**FINAL
NAVAL AIR STATION ALAMEDA RESTORATION ADVISORY BOARD
MEETING SUMMARY**

December 7, 2006

**RAB COMMENTS ON THE PROPOSED PLAN FOR IR SITE 1
AND REVIEW BY TAPP CONSULTANT**

ATTACHMENT B-3
PROPOSED PLAN FOR IR SITE 27
(10 Pages)

Site 2 - Wetlands

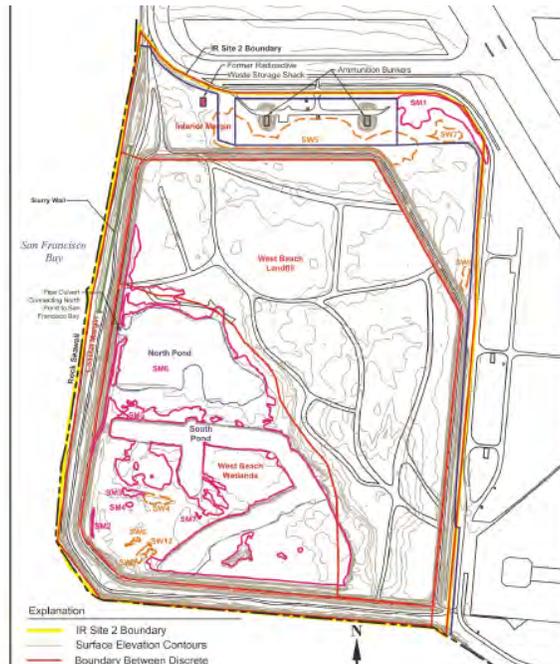
Slide 3 was a map of the wetlands within Site 2. Mr. Strauss identified the footprint of the landfill, the salt marsh wetlands, seasonal wetlands, the radioactive waste storage shack, and the slurry wall on the Site 2 map. He noted that the landfill overlaps the salt marsh wetlands in some areas. The slurry wall was built in the 1980s to prevent migration of waste into the bay.
